**City of Mesa -
Administrative Review**
Cityview cases ADM23-00243 and ADM23-00254

Re-Submittal of Corrections:

- Loading Dock Elevation Windows,
- Overhead Door Canopies,
- Panel "Arch" Relief

Germann Industrial Park

**EXTERIOR
ELEVATIONS
BUILDING B**

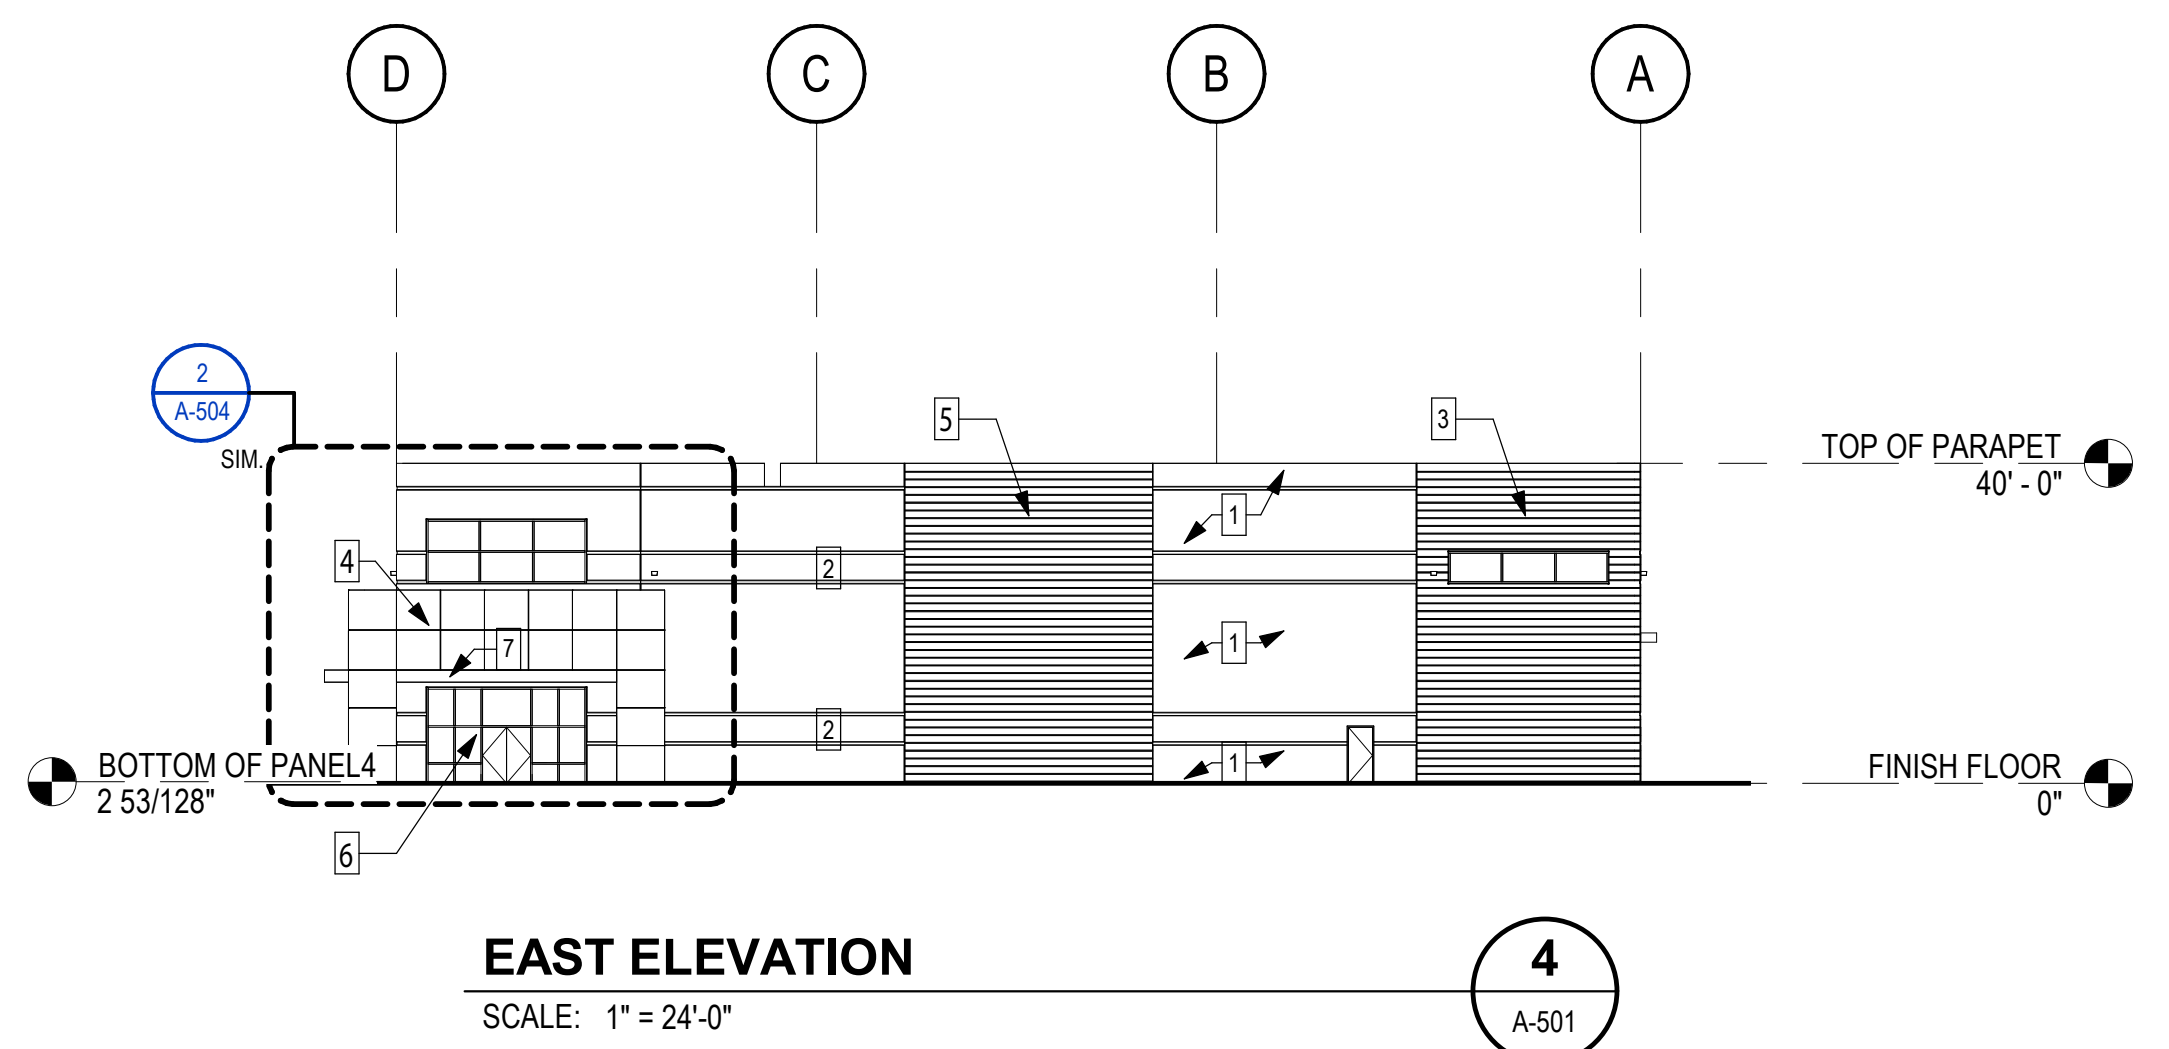
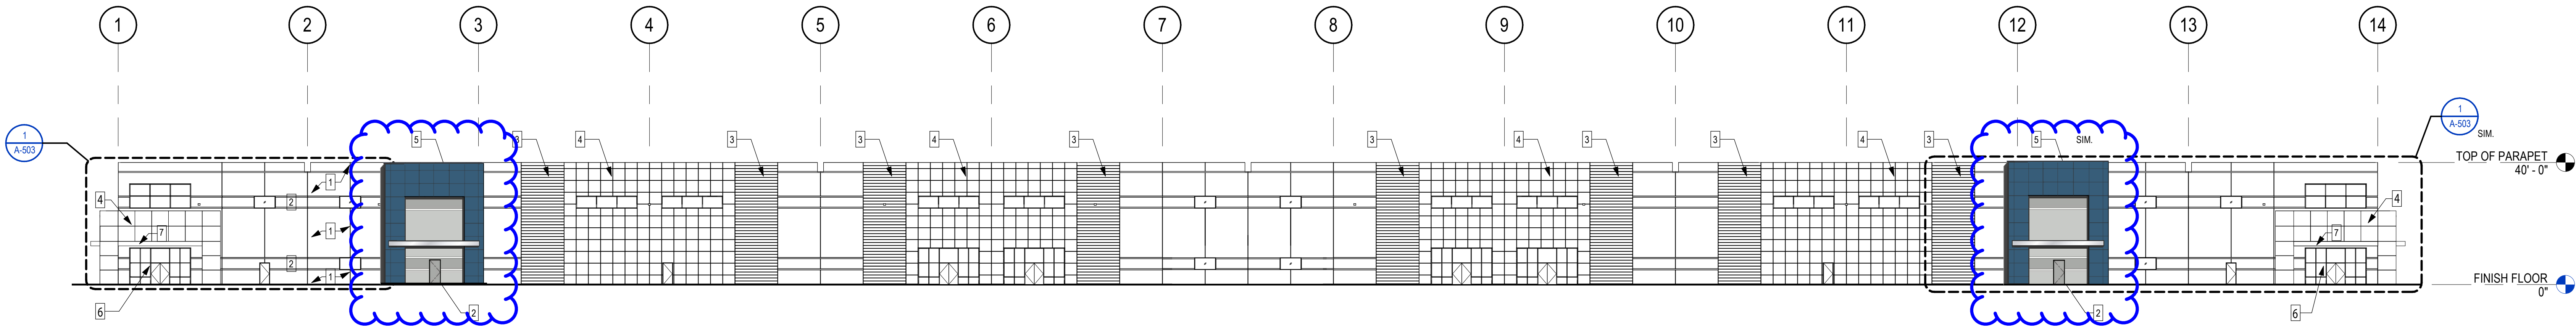
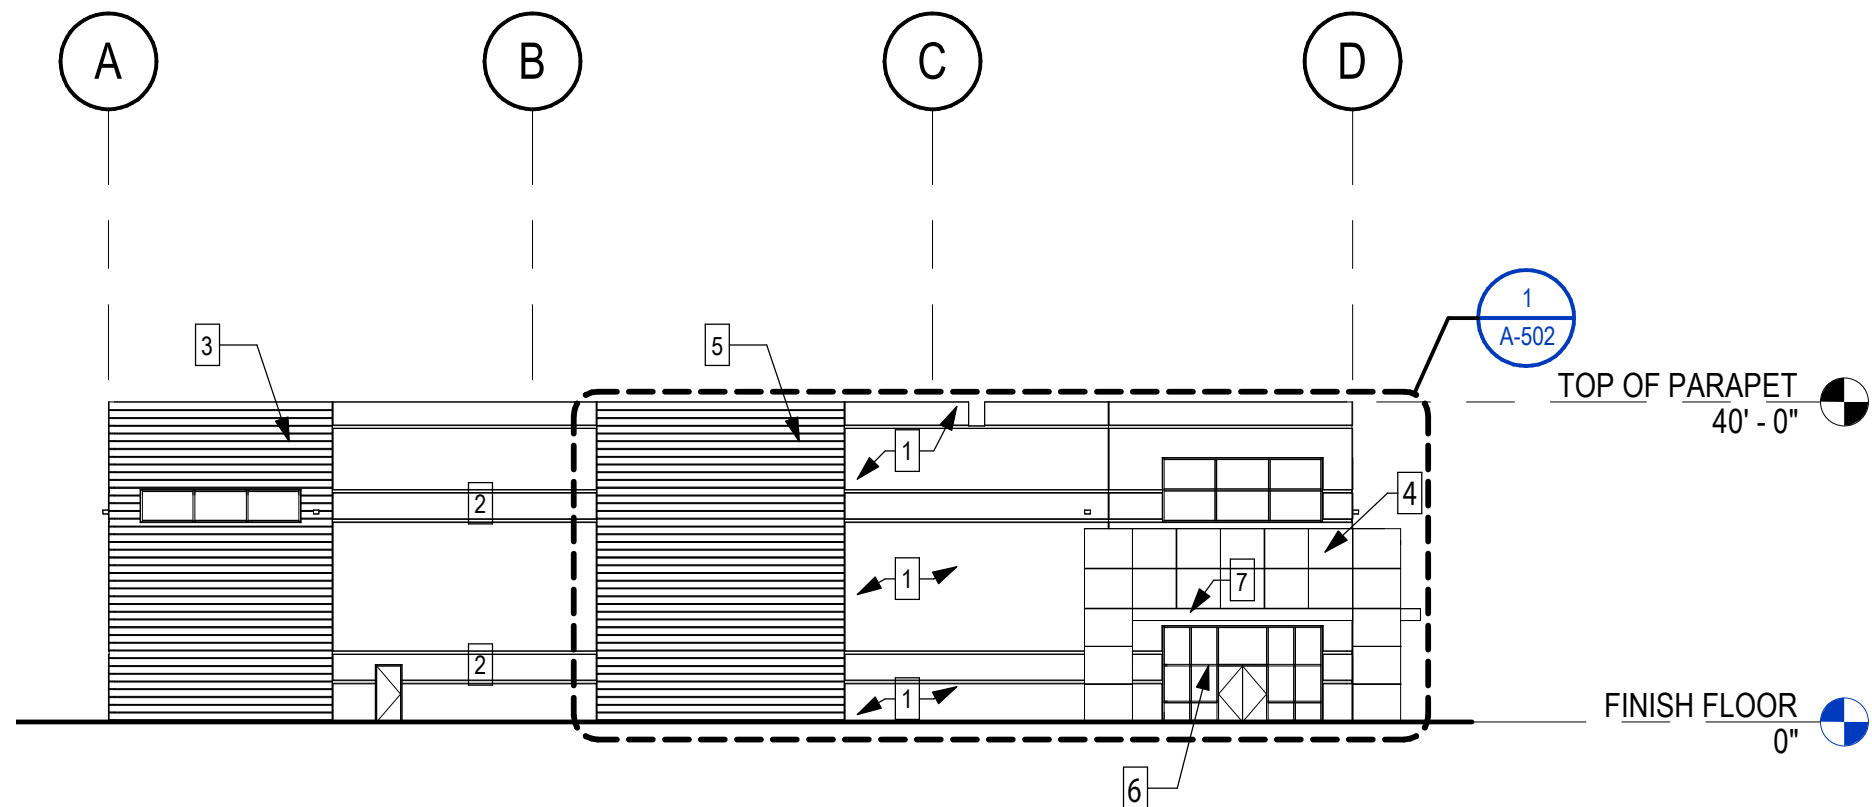
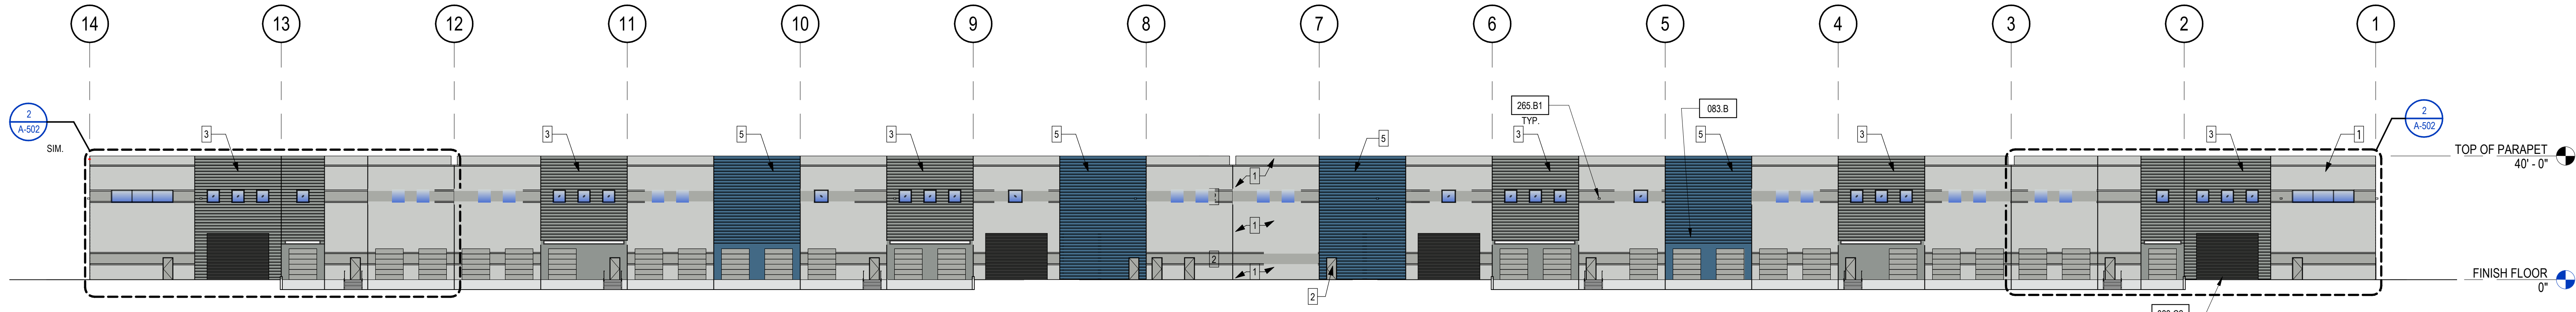
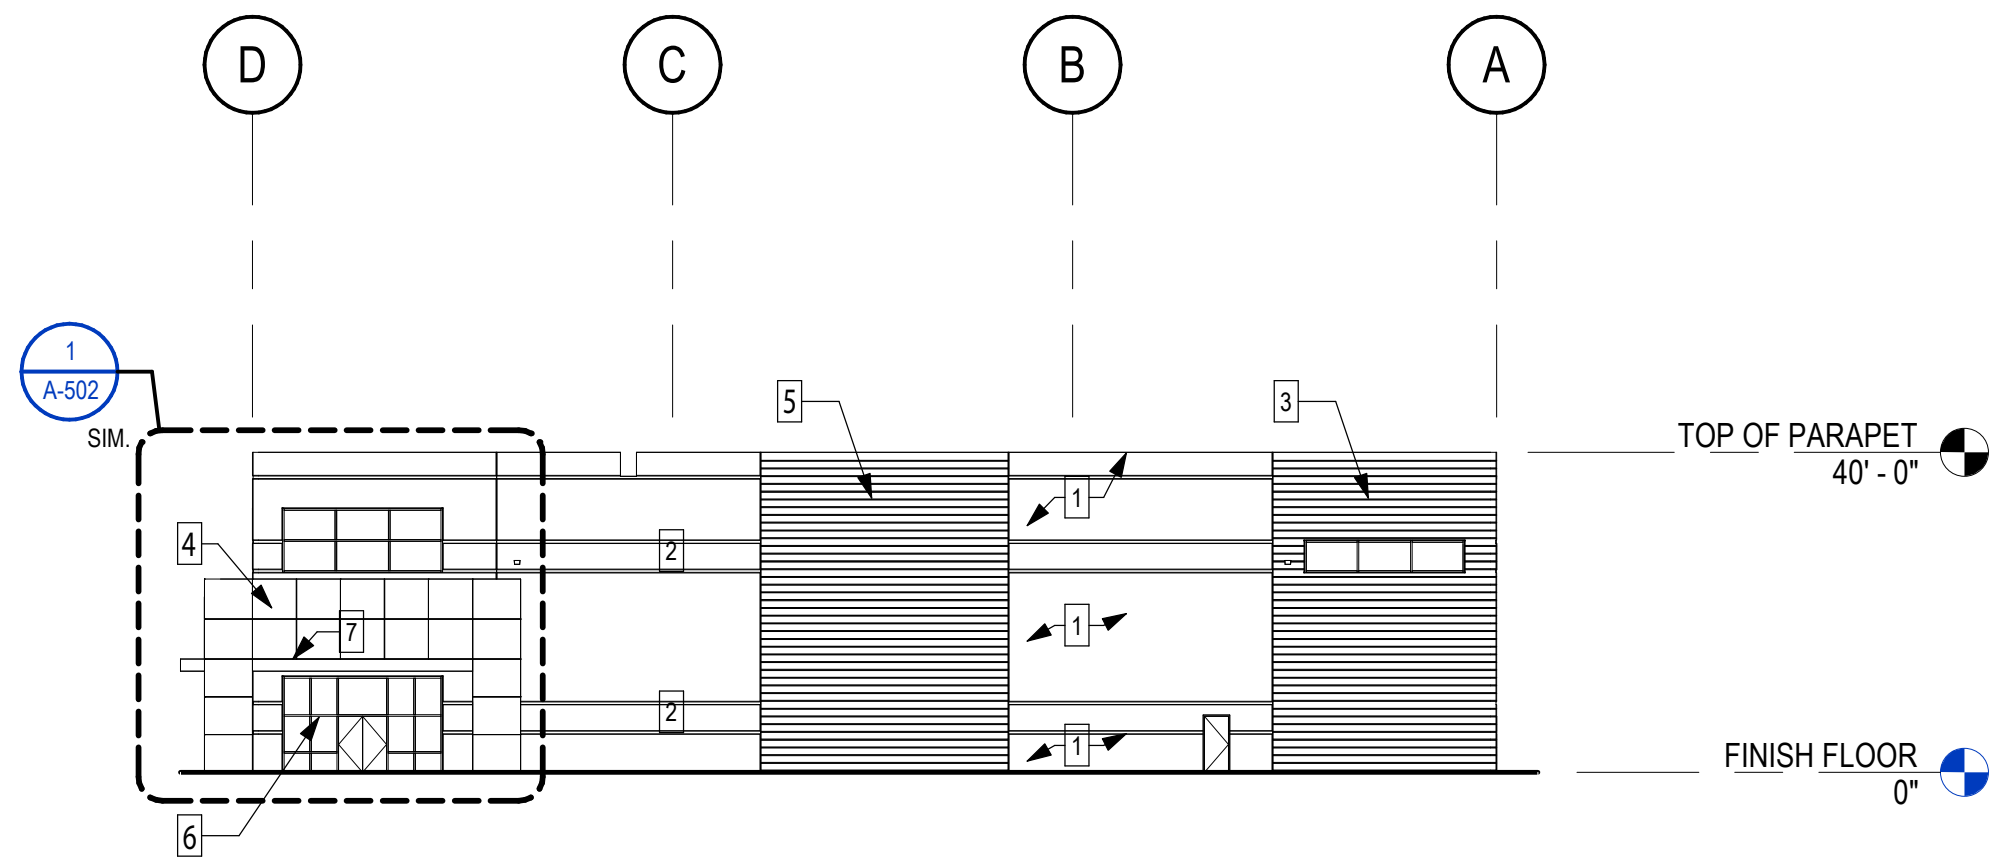
Re-Submittal of Corrections:

- Loading Dock Elevation Windows
- Overhead Door Canopies,
- Panel "Arch" Relief
